DRAFT DECISION
TransGrid transmission
determination
2018 to 2023

Attachment 6 – Capital
expenditure

This attachment forms part of the AER's draft decision on TransGrid's transmission determination for 2018–23. It should be read with all other parts of the draft decision.

Figure 6-5 TransGrid - Coincident weather adjusted peak demand 50% POE

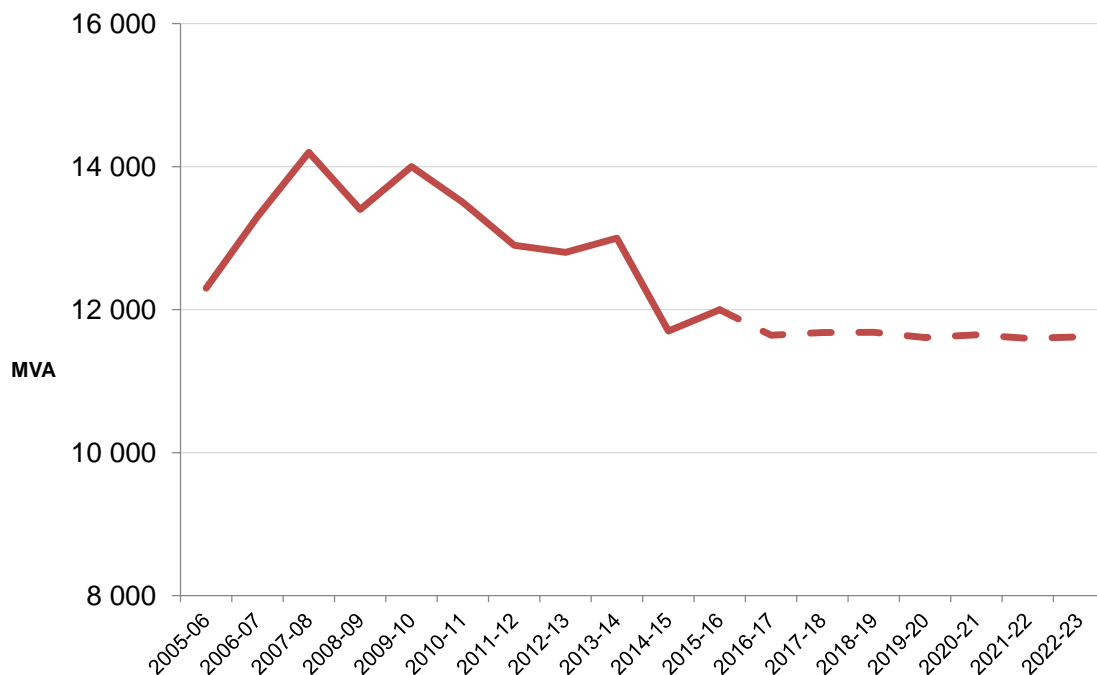
Figure 6-5 shows TransGrid has experienced a sustained downward trend in peak demand since 2007-08. Further, we note that TransGrid is projecting peak demand to be flat across the 2018-23 regulatory control period. This indicates that in an operating

Figure 6-8 TransGrid - Actual and forecast expenditure - Line/tower renewal (\$2017-18)

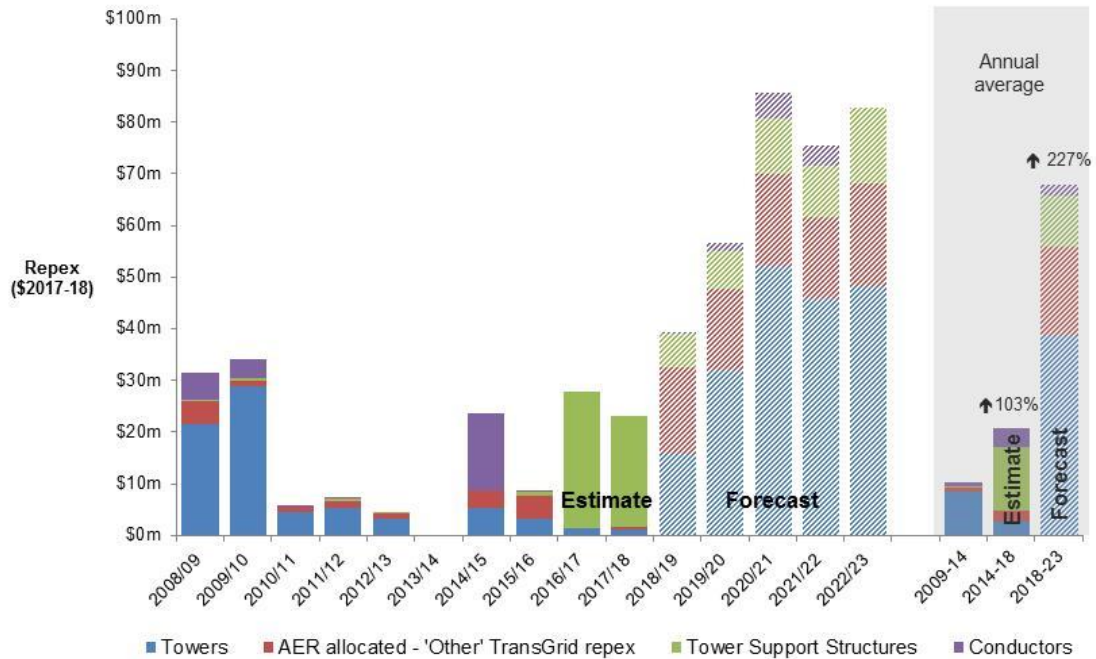
information in support of this proposed capex. As outlined in our key findings regarding our forecasting methodology review, we consider that this expenditure forecast is overstated.

TransGrid's highest risk cost, with regards its proposed \$342.6 million transmission line repex (see Figure 6-8 on page 6-60) is associated with the 'environment' category. This is due to the 'value of risk' that TransGrid places on the consequences of a bushfire event resulting from conductor drop failure.

Figure 6-10 TransGrid - Substation security

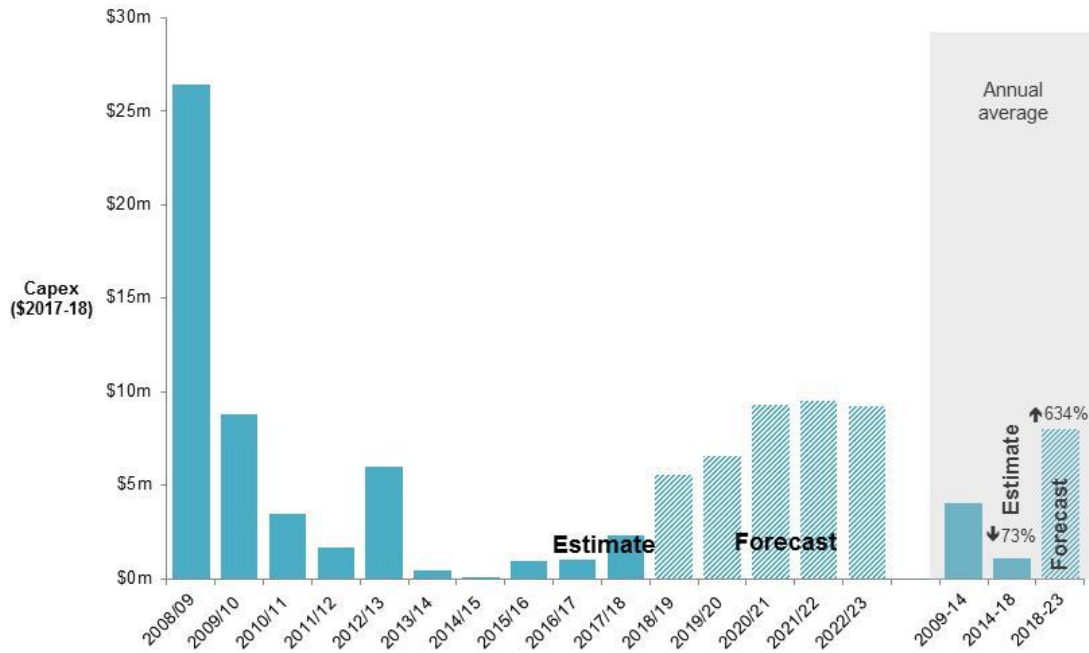
TransGrid's forecast substation security capex represents a large increase from recent historical levels (see Figure 6-10). TransGrid submitted that no major substation security projects have been required since the completion of a major program of fence and gate upgrades in the late 2000s, as no risk based issues were identified.¹³⁴ TransGrid also submitted that the historical capex trend is not representative of capex required for the next regulatory control period on the basis that proposed capex is primarily driven by:¹³⁵

As outlined in our key finding regarding our forecasting methodology review, we consider that this expenditure forecast is overstated.

Figure 6-12 TransGrid - Areas of low incremental benefit (risk reduction)

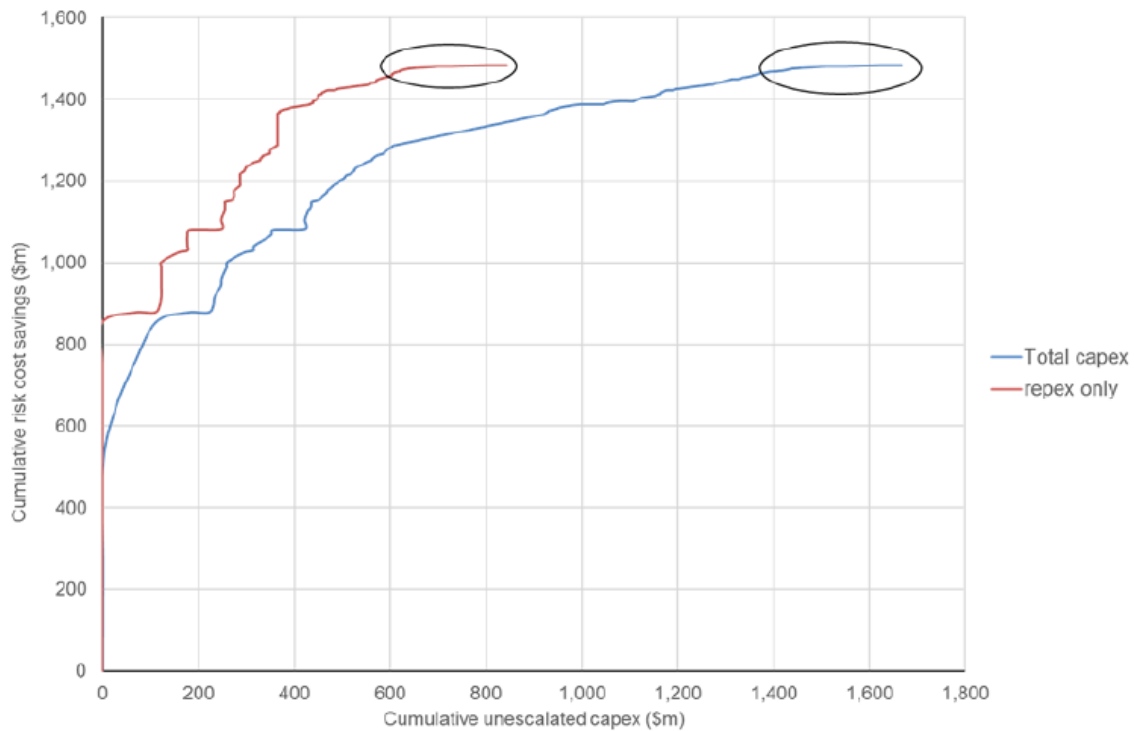
In considering the total proposed capex, EMCa also compared the aggregate value of risk reductions associated with the aggregate value of the proposed capex portfolio and identified that a significant amount of proposed capex is expected to be associated with limited reductions in the value of risk (Figure 6-12).

Relevantly, Figure 6-12 indicates that around \$200 million of proposed capex (and repex) provides limited value in terms of reductions in risk (i.e. the benefit gained is negligible when compared to the money invested). This \$200 million represents around 20 per cent of proposed repex (including security and compliance driven repex).

Figure 6-13 TransGrid - Proposed repex by risk category

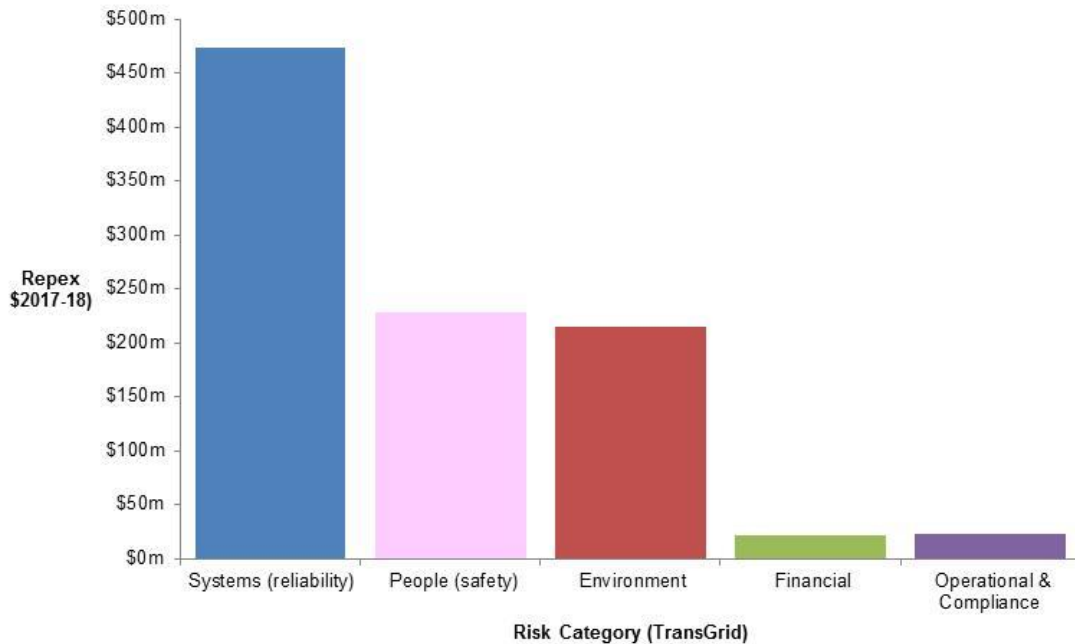
As is indicated in Figure 6-13 (page 6-69), environmental and safety related risk is the primary driver for over \$400 million of TransGrid's capex forecast.

issue on the basis that TransGrid's estimated environmental risks (bushfire) is the primary driver of around \$200 million of proposed repex (refer to Figure 6-13 on page 6-69).

We estimate that around \$200 million of proposed repex includes ALARP in the analysis. This is consistent with the vales shown in Figure 6-13 (page 6-69) which indicates that safety risk is the primary driver for around \$200 million of proposed repex.²²⁰ However, EMCa found that TransGrid's annualised capex calculation is flawed wherever its ALARP test has been applied.²²¹ In particular, EMCa found that:

Figure 6-14 TransGrid - Network related fire starts

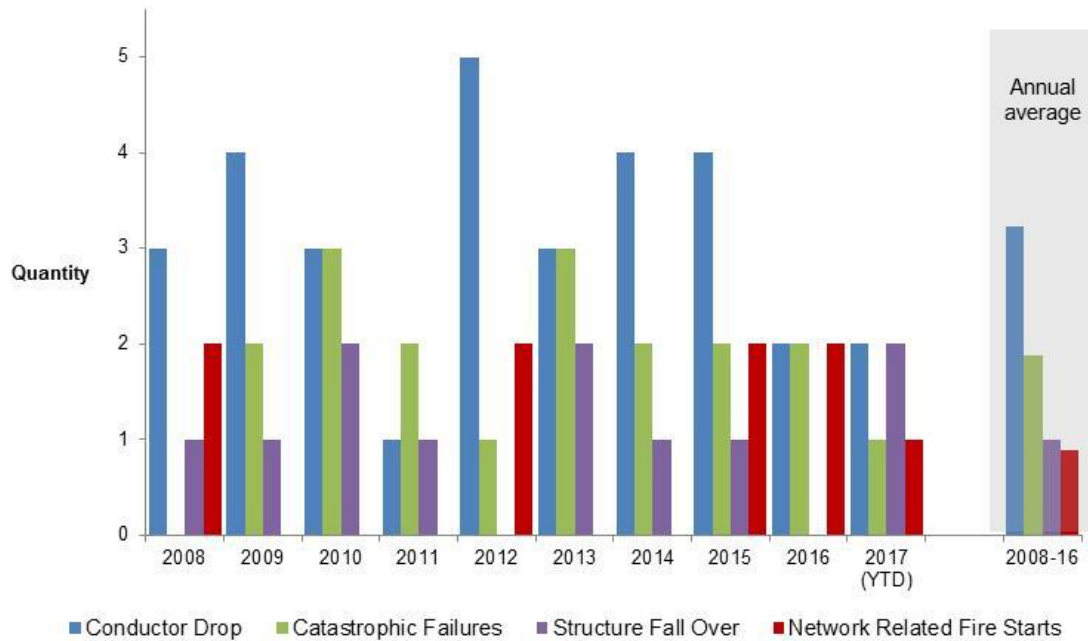
Evidence provided by TransGrid indicates that the relationship between conductor drops and fire starts over the past 10 years is significantly less than 1:1 (see Figure 6-14).

Figure 6-21 Comparison of EUE before and after removing planned events

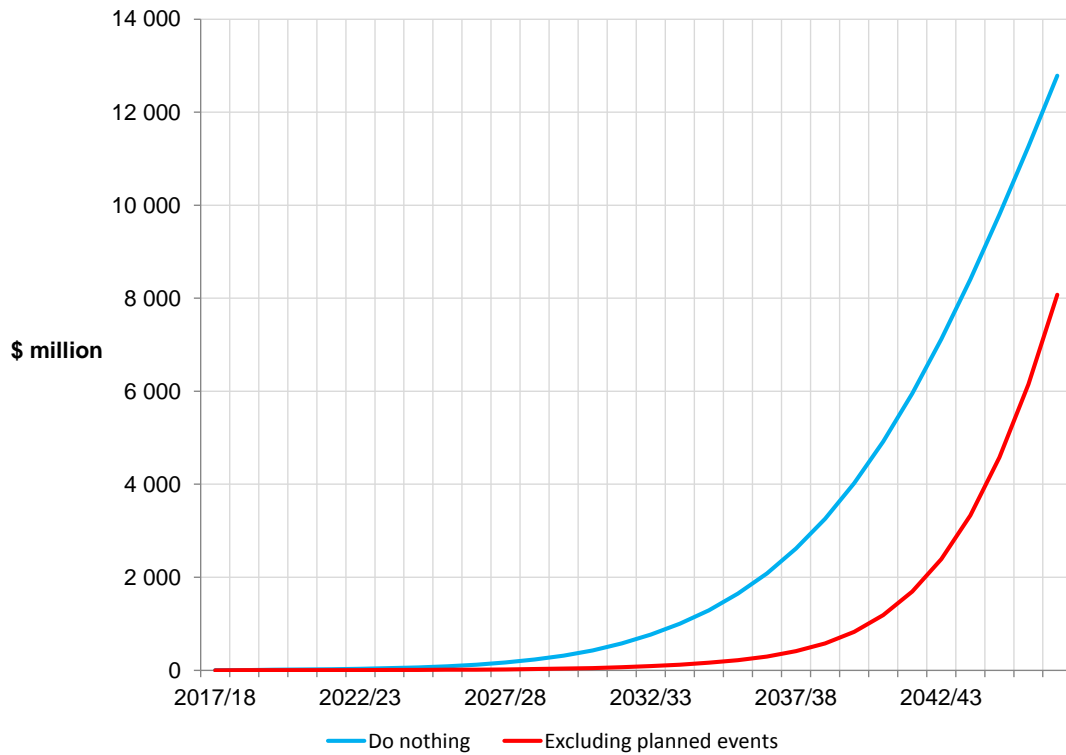
However, TransGrid provided no sensitivity analysis to support this view. As indicated in Figure 6-21, we consider that the analysis is sensitive to these assumptions.

Figure 6-21 below shows the difference between TransGrid's estimate of the value of unserved energy in the "do-nothing" scenario (i.e. no network investment), and an estimate of the value of unserved energy derived from 'excluding planned events'

As shown in Figure 6-21 the impact on the value of unserved energy which neutralises the inclusion of planned outage events in the cable failure data reduces the value of unserved energy and impacts on the optimal project timing. Figure 6-22 shows that the optimal timing for commissioning the project is likely to be beyond the 2018-23 regulatory control period.

Figure 6-26 TransGrid - Optimal project timing (cable capacity based on emergency ratings)

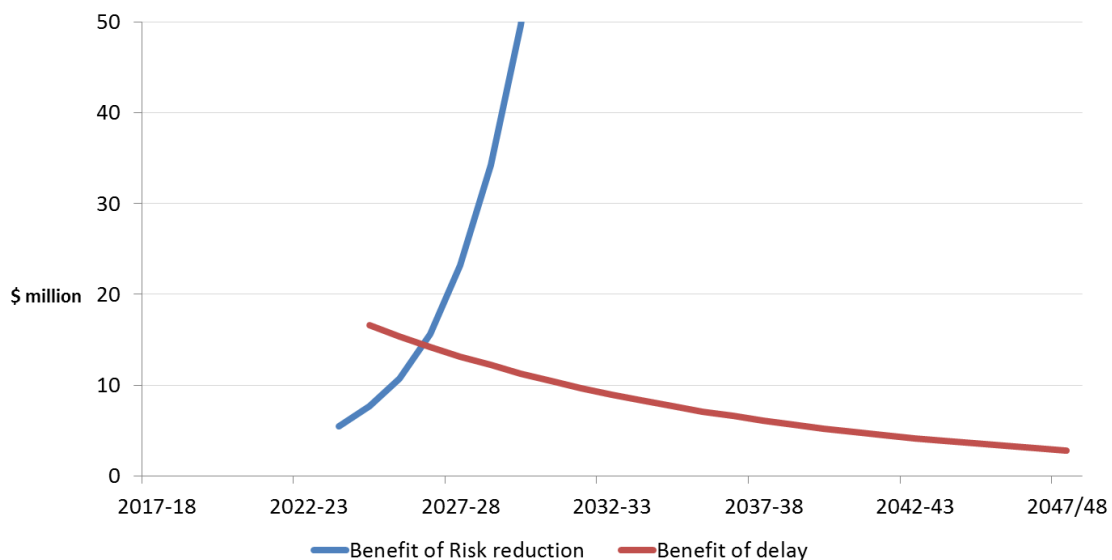
Relevantly, Ausgrid advised that capacity should be based emergency ratings during cable outages.³¹² Our internal technical analysis considers that emergency ratings should be used to determine expected unserved energy in this modelling scenario. The adoption of emergency ratings will increase the effective network capacity and reduce the estimate amount of assumed unserved energy and impacts on the optimal project timing. Figure 6-26 shows that the optimal timing for commissioning the project is likely to be beyond the 2018-23 regulatory control period.

Figure 6-26 shows an indicative commissioning date around 2026-27 (assuming the adoption of all other Ausgrid inputs (i.e. cable un-availabilities, maximum demand and the value of unserved energy per customer)).

Figure 6-29 Optimal project timing (AEMO Sydney wide forecast)

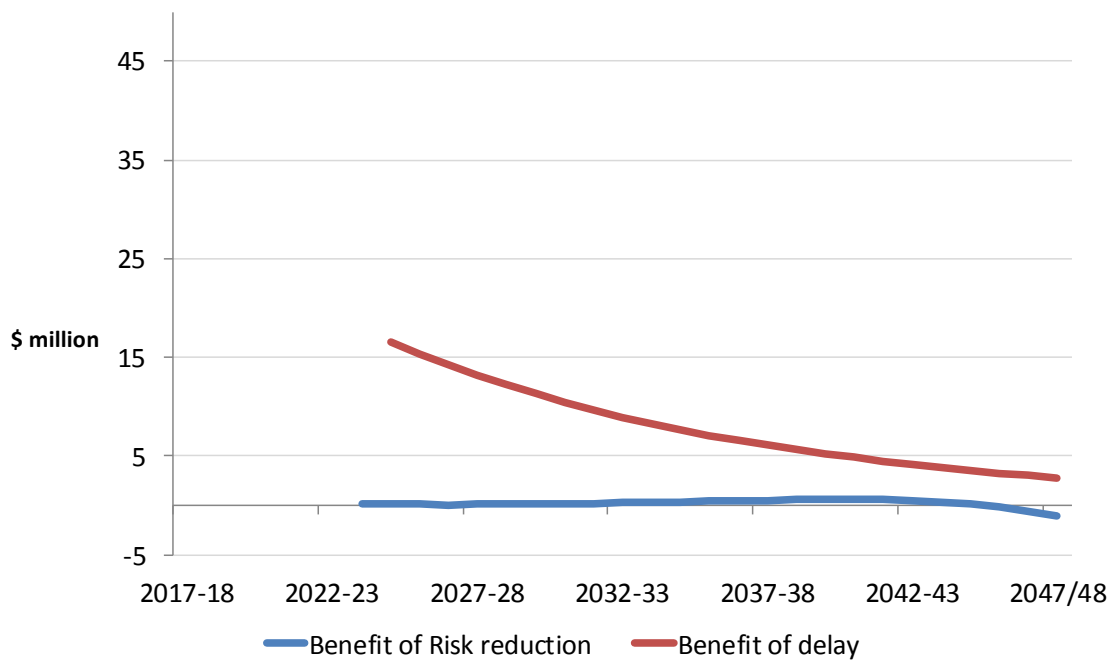
As shown in Figure 6-29, if the AEMO Sydney wide forecast is adopted the project, the project is not economically justified (but adopting all other Ausgrid assumptions on cable capacity, un-availabilities and VCR).

Figure 6-30 Optimal project timing (BIS Shrapnel forecast, including Ausgrid spot loads)

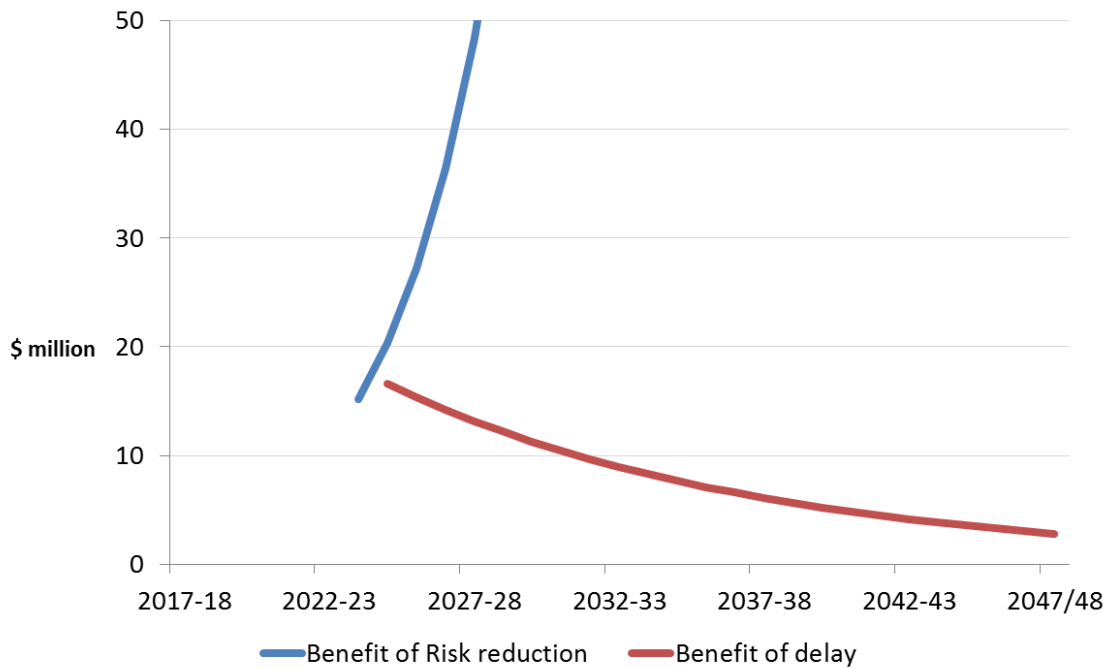
Figure 6-30 below shows that if the underlying BIS Shrapnel forecast, including Ausgrid spot loads is adopted, the optimal project timing is closely aligned with TransGrid and Ausgrid’s proposed project timing (assuming that all other Ausgrid assumptions on cable capacity, cable un-availabilities and VCR are adopted). This indicates that Ausgrid’s spot load forecast (229MW) is a critical assumption.

Figure 6-31 Optimal project timing (alternative assumptions)

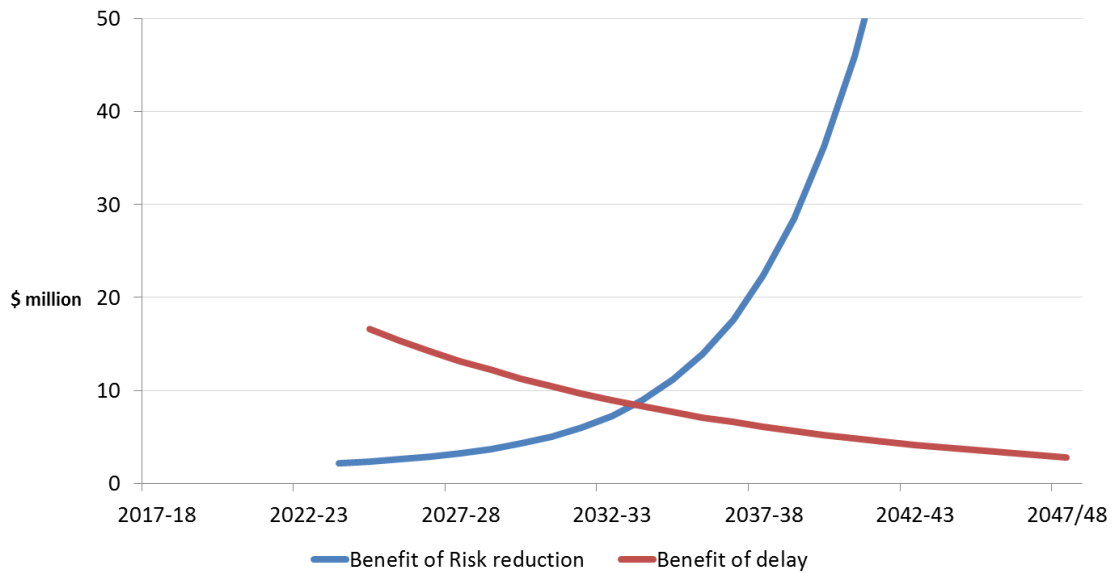
Figure 6-31 shows that the optimal timing of the project is likely to be well beyond the 2018-23 regulatory control period if the assumptions identified above are adopted.

Figure 6-32 Macarthur bulk supply point - maximum demand (MVA)

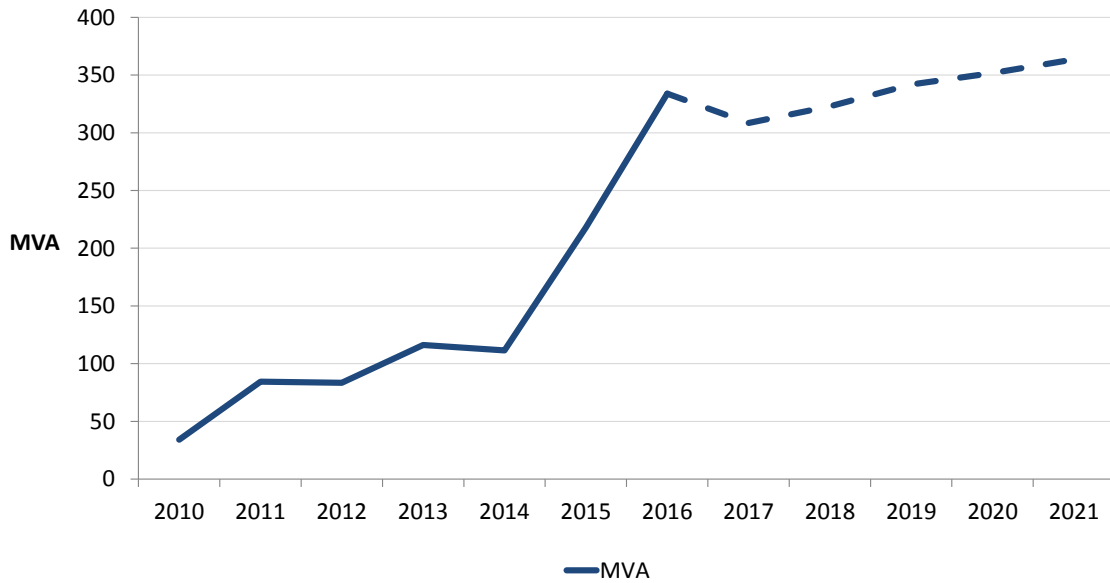
Figure 6-32 shows that since 2014 there have been significant increases in peak demand on the Macarthur bulk supply point and this is forecast to continue increasing, albeit at a lower rate. We are satisfied that the scale of the developments in the Macarthur area will mean network augmentation is likely to be required within the 2018-23 regulatory control period on the basis of localised demand growth.

Figure 6-33 Vineyard bulk supply point - maximum demand (MVA)

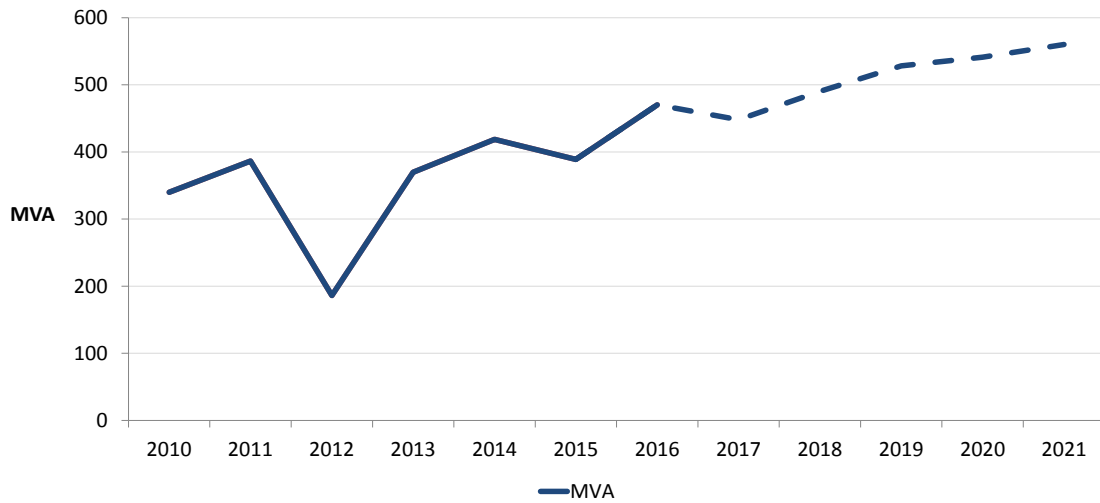
Figure 6-33 shows that since 2012 there have been significant increases in peak demand on the Vineyard bulk supply point. Though Endeavour Energy is forecasting a lower rate of peak demand growth through the 2016-21 period. This supports the likely need for this project during the 2018-23 regulatory control period. We are satisfied that the scale of the developments in the Box Hill area will mean network augmentation is required on the basis of localised demand growth.
